SLG46620-EV Errata Note

This document contains the known errata for SLG46620-EV and the recommended workarounds.

3.2 ACMP Output Glitch due to Ring OSC Operation

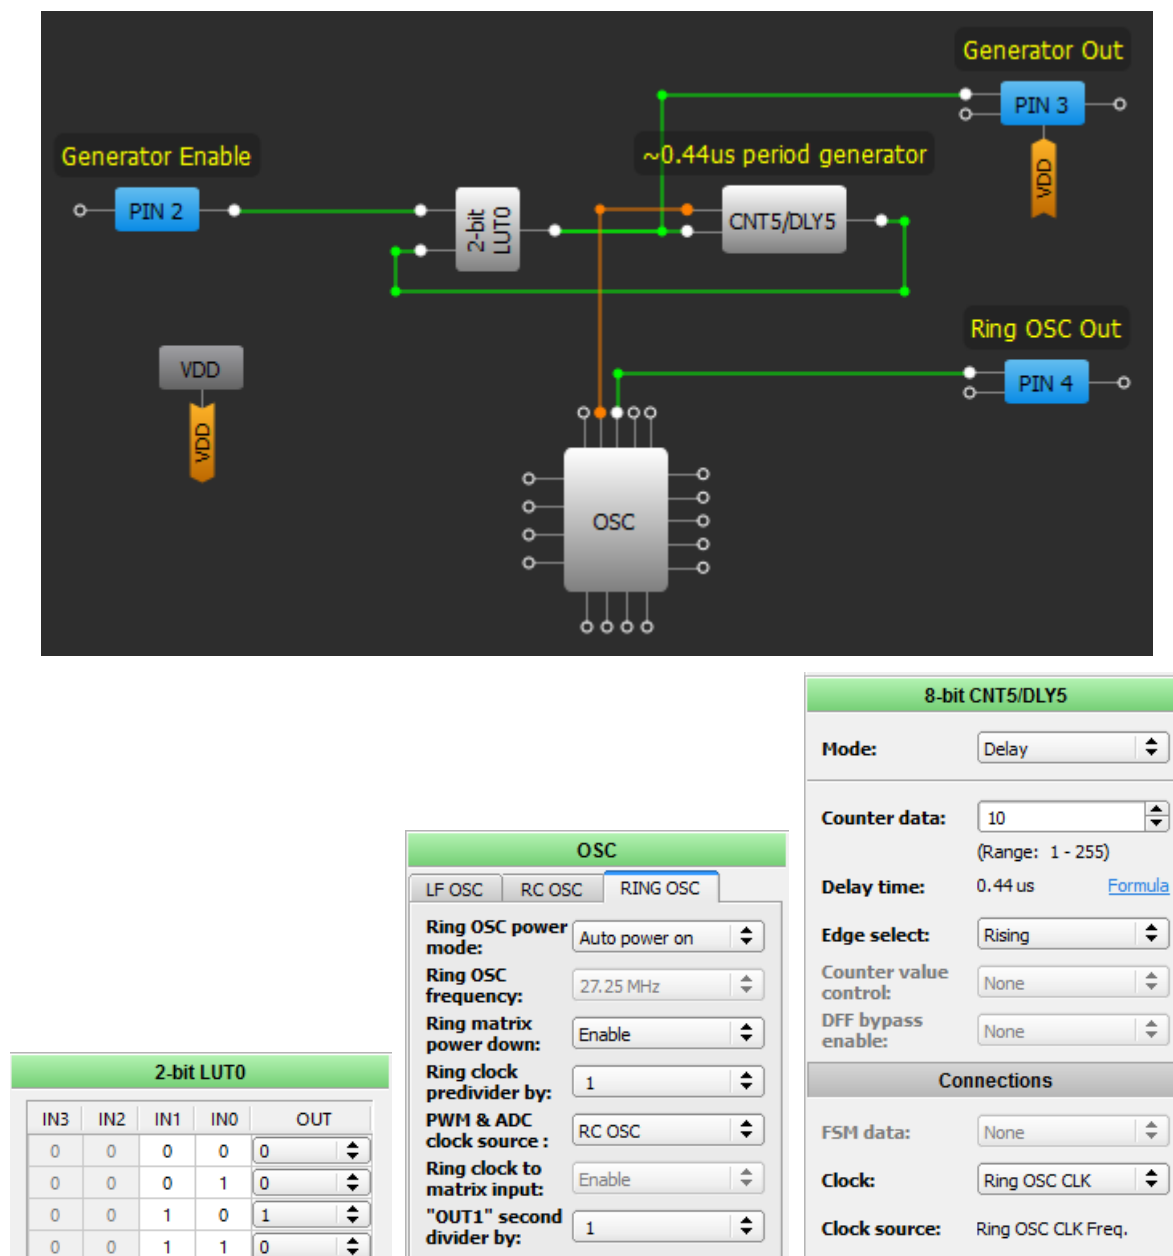
The output of the ACMP incorrectly goes low even when IN+ is greater than IN- if the RING OSC is active when the WS signal rises.

Avoid using the RING OSC with the WS Controller, or add a filtering block on the ACMP output to filter out the glitch.

3.3 Long Ring OSC Settling Time

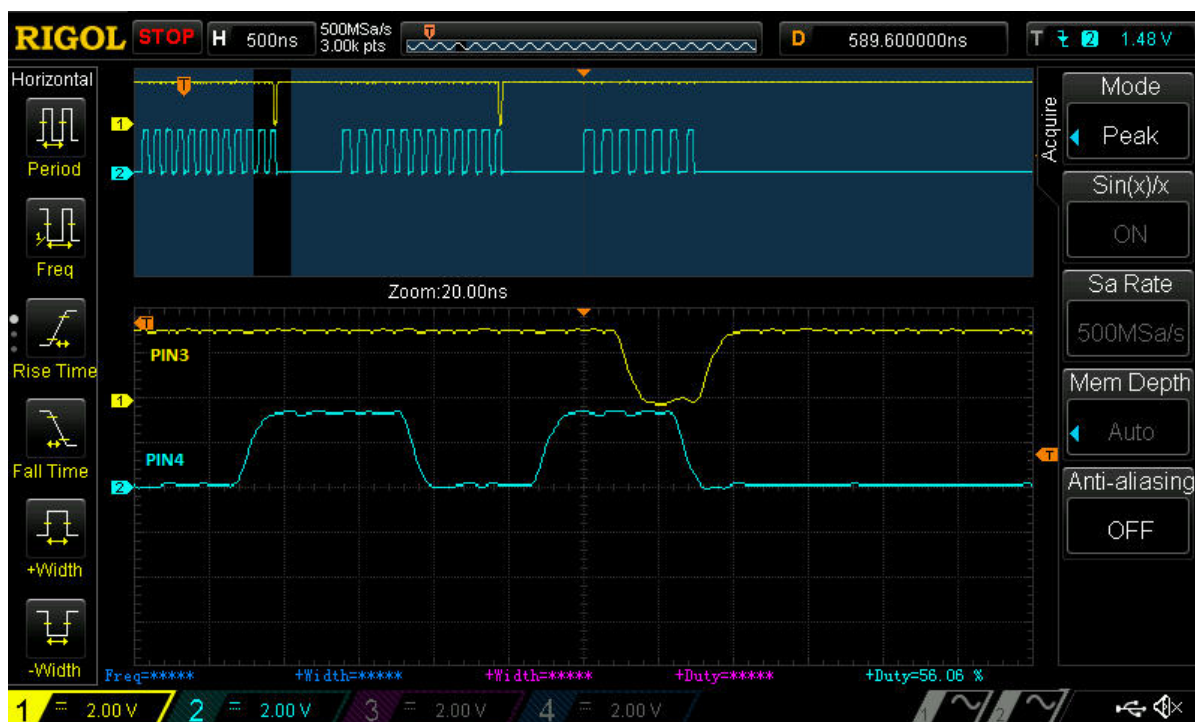
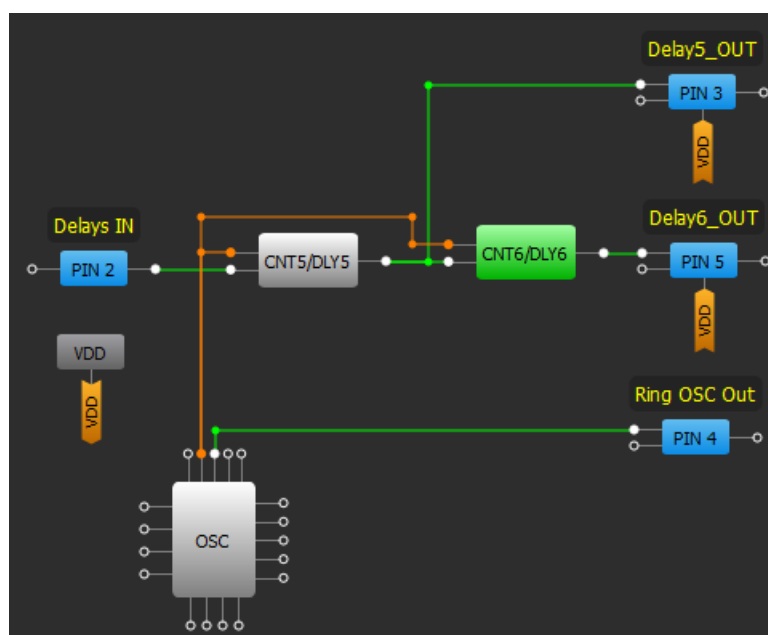
The Ring OSC has a longer settling time when configured as Auto Power On in the designs that have very short Ring OSC disable time. An example of this issue is shown in the following configuration:

The configuration shown above generates a periodical signal with a frequency defined by the Delay cell and started by a high signal on PIN2. The issue becomes apparent in a longer settling time when the scheme generates short pulses (Delay is configured as a rising edge delay only). See waveform below.

Such behavior will lead to substantial error in period calculations if the delay time is relatively small.

A similar situation can occur while using two connected delays (all edge detect types except for a pair “Rising edge DLY – Falling edge DLY”).

In the following example, Delay5 and Delay6 are configured in the same way. However, Delay5 time is 11.4us instead of expected 0.4us (Delay5 time).

- Set Ring OSC power mode to “Force Power On”
- or, Set Turn on by register option in BG (Band Gap) block as “Enable”

3.4 PGA has an Offset when Loaded

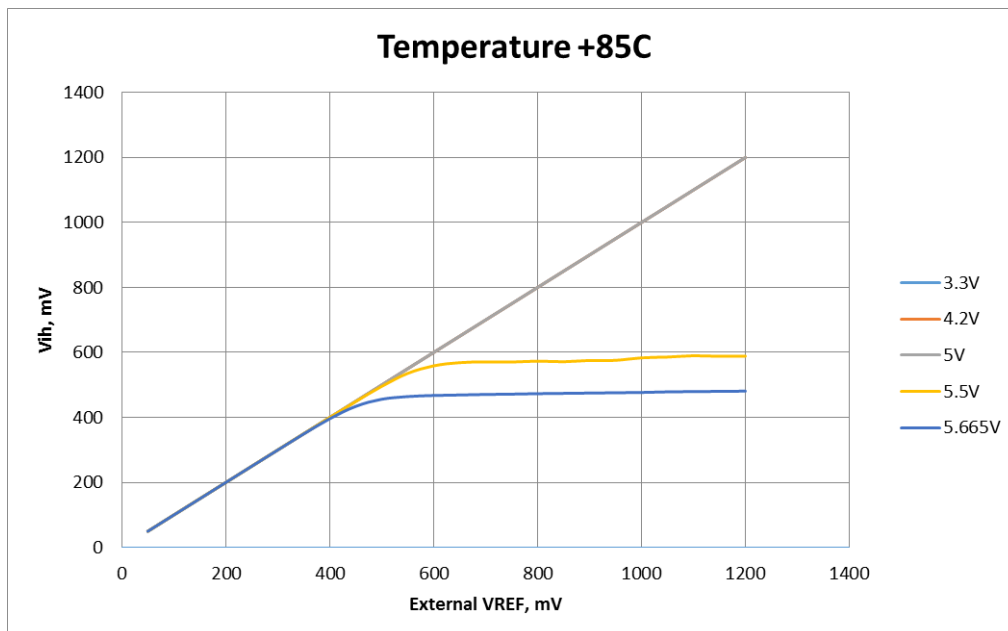
The PGA block has an offset when its output through the VREF is loaded. For reference, the table below shows the load vs PGA 4x gain.

When the load current is higher than 10 mA the output offset is large and may influence the design operation significantly.

Use an external buffer to support high load.

3.5 ACMP Output is Inaccurate when Using External Vref at High VDD and Temperature

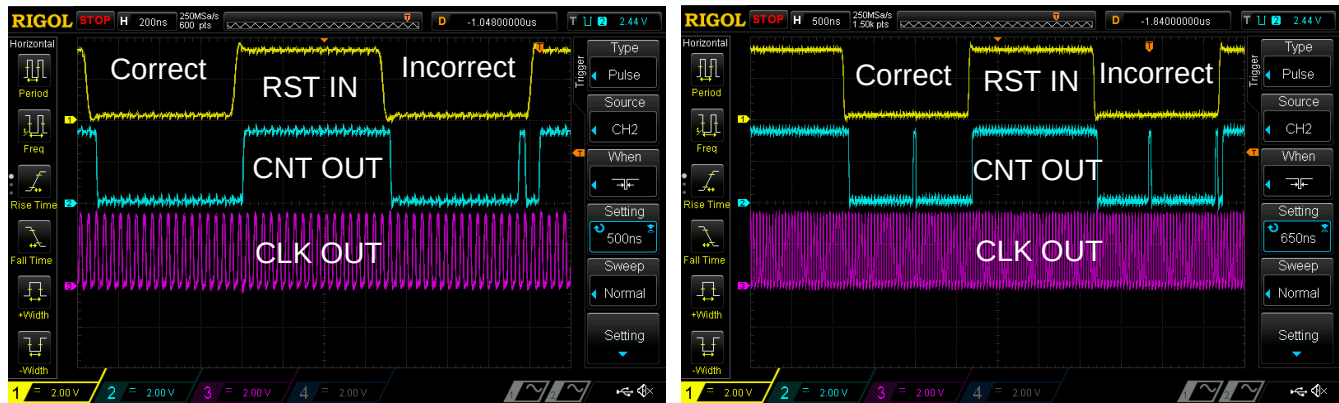
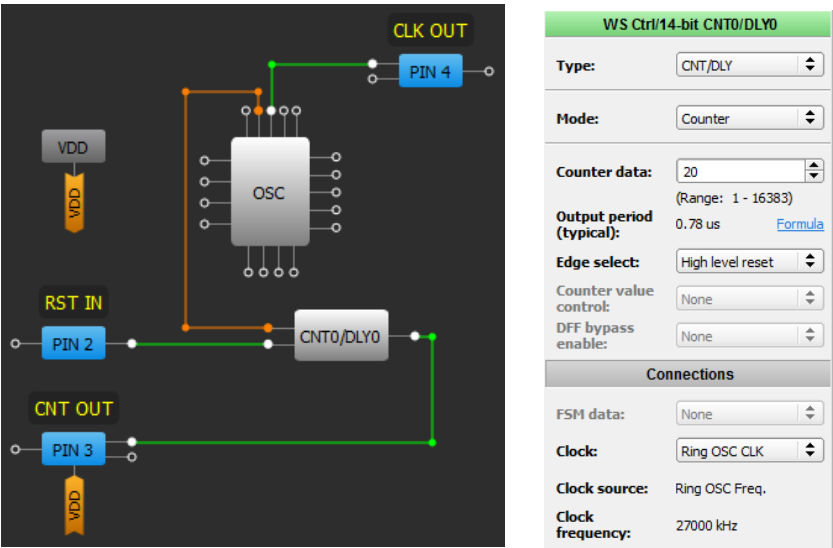
When using external Vref source, the ACMP comparison may happen at wrong threshold if the external Vref voltage is higher than a particular value (please see figure below) at high VDD values (> 5V) and high temperature.

Avoid using ACMPs in such conditions.

3.6 Incorrect Counter Operation after the Reset

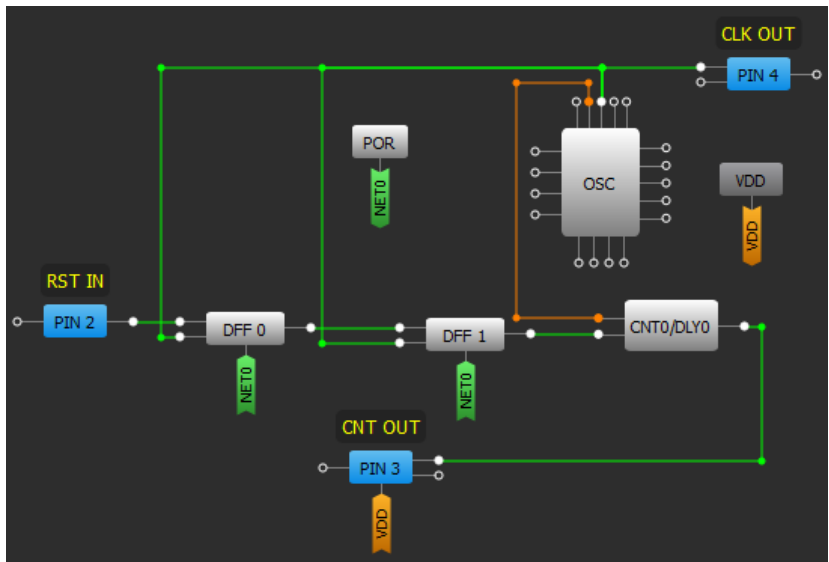
If the Counter Reset occurs at a time very close to a rising edge of the clock signal during clock signal generation (for example OSC operation), there is a possibility that the Counter Data of the Counter is reset incorrectly and the counter end signal (HIGH pulse) may appear faster than expected. This phenomena appears more frequently the higher the clock frequency is.

Synchronize RESET input of the Counter with its CLK using 2 DFF cells as shown in the image below.

3.7 DCMP OUT+ Output Glitch

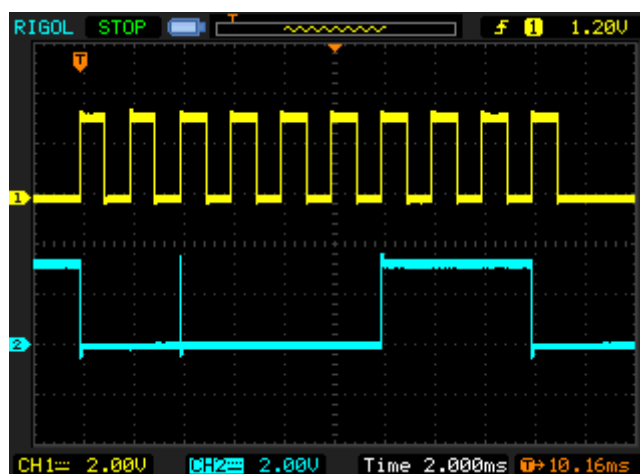
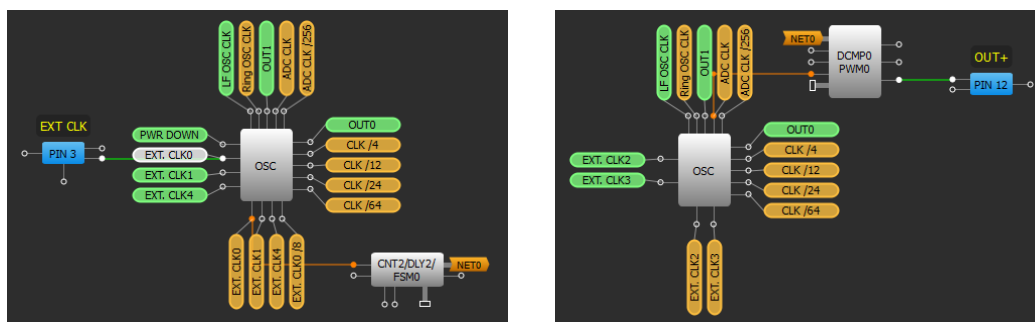
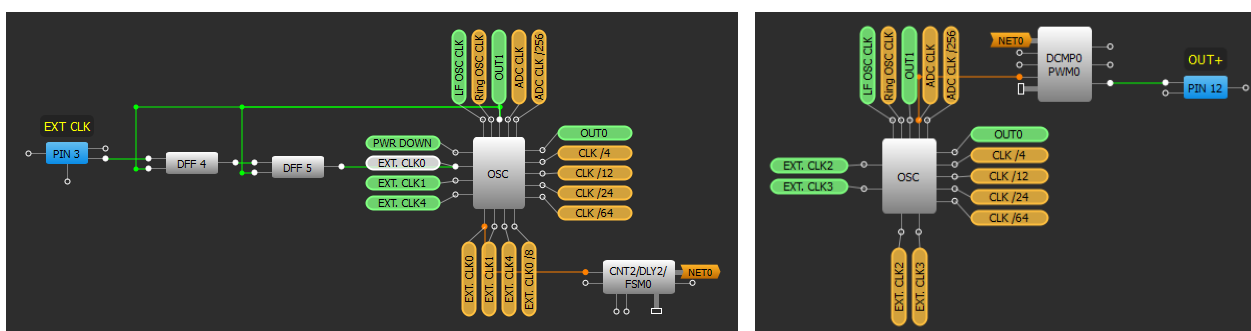
DCMP's OUT+ output may have a glitch when the input data is changed. This issue appears more frequently the higher DCMP clock is.

For example, DCMP IN+ sources from FSM0 and IN- from Register0. DCMP is clocked from the Ring OSC.

Synchronize the data source clock with the DCMP clock source using 2 DFF cells as shown in the images below.

3.8 OSC Long Start-Up Time

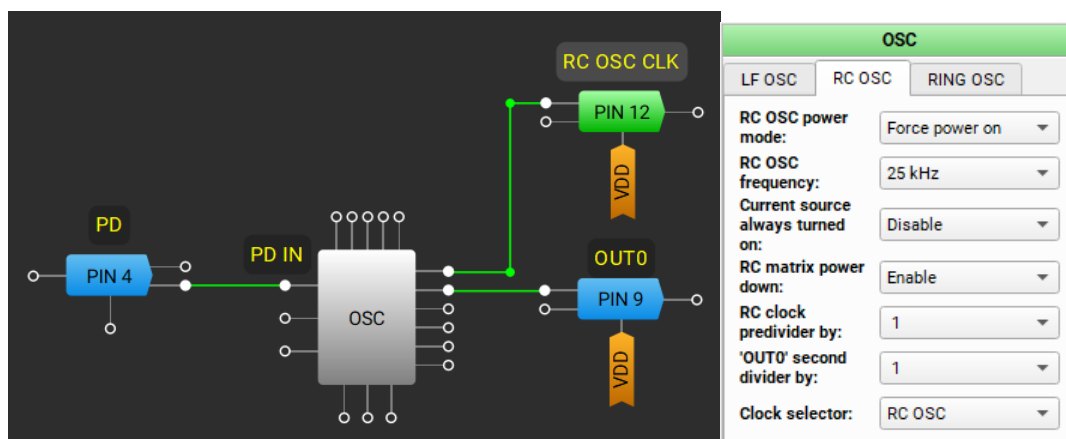
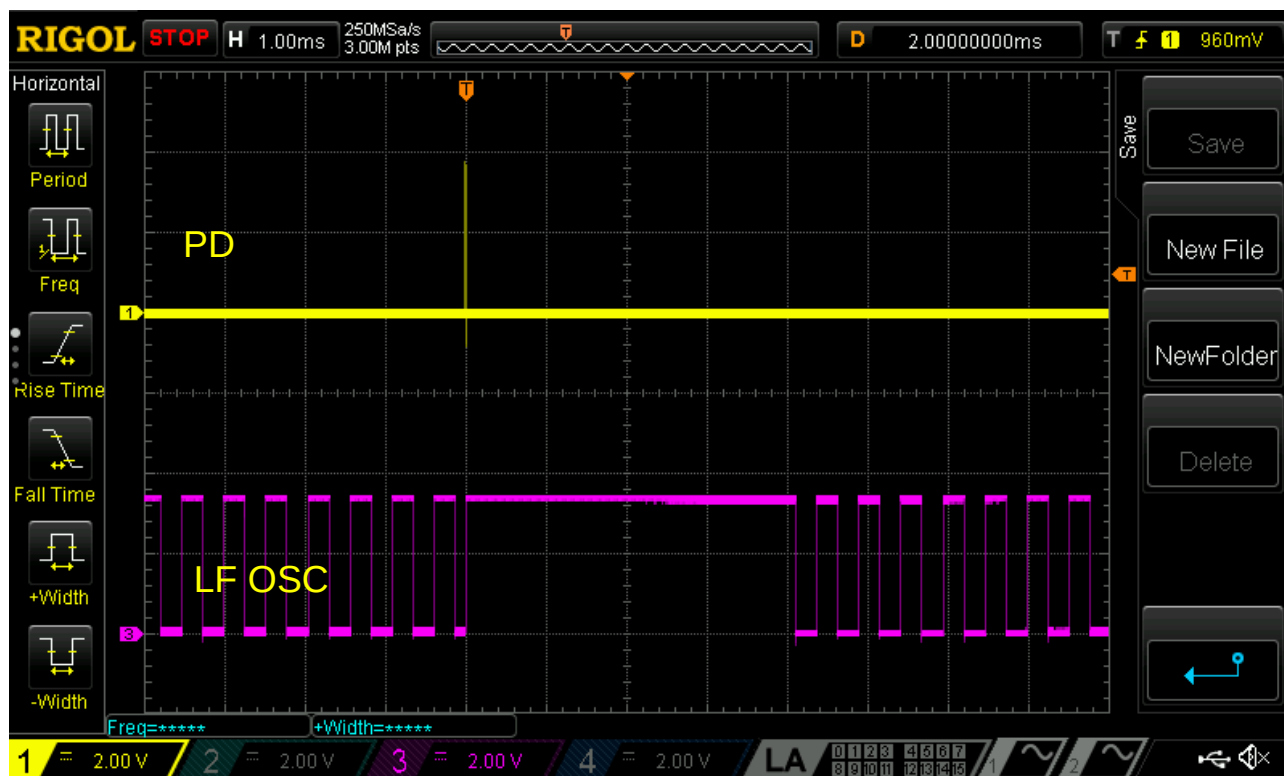
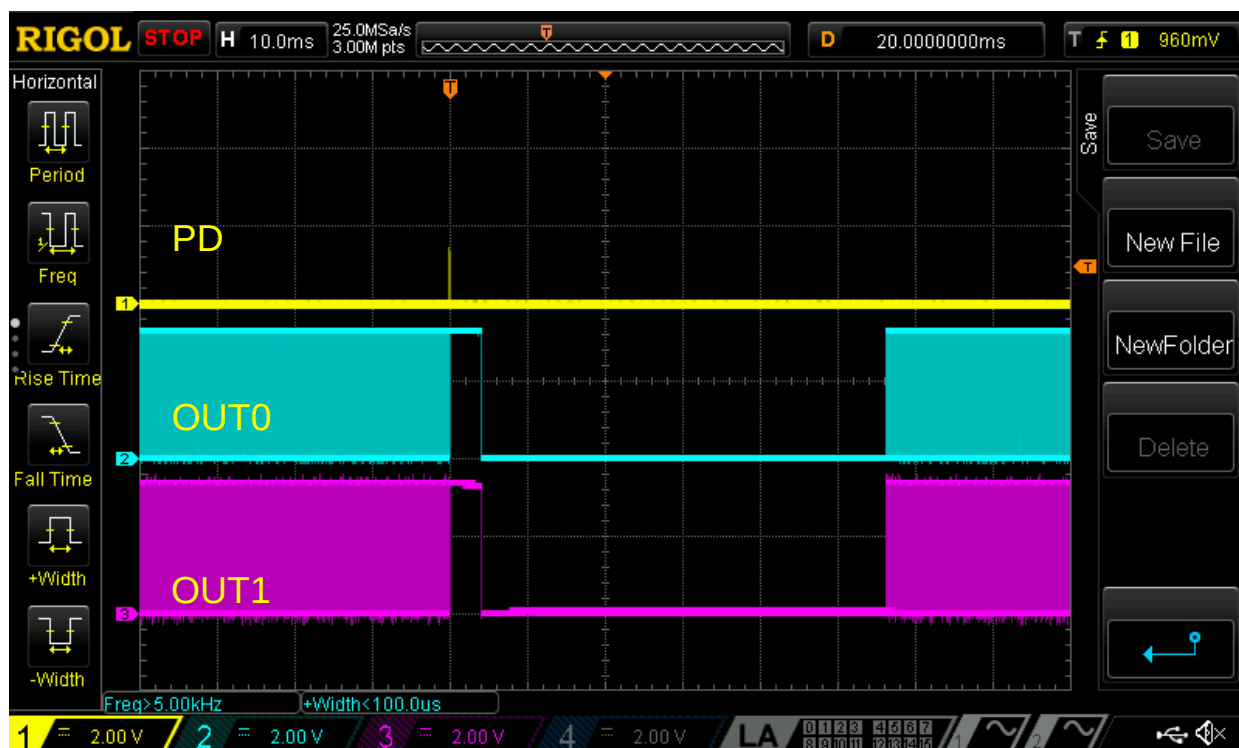
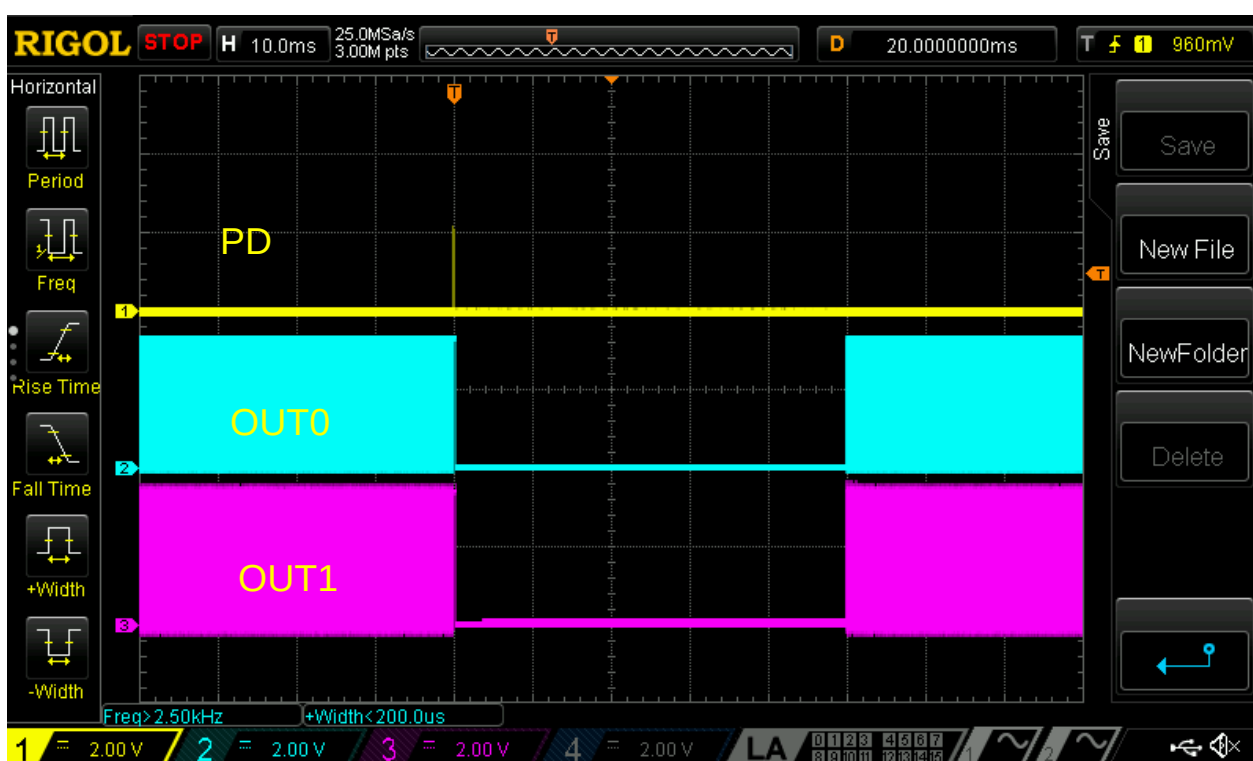
When a short pulse is applied to the PWR DOWN input, the oscillator exhibits a long start-up time.

When a short pulse of less than ~40 ns is applied to the PWR DOWN input.

If a pulse with a duration of less than ~40 ns is applied to the PWR DOWN input of the oscillator, the oscillator outputs remain stuck for milliseconds, as shown in Figure 16 and Figure 17. The issue is observed for all available oscillators.

Avoid applying glitches to the PWR DOWN input of an OSC.
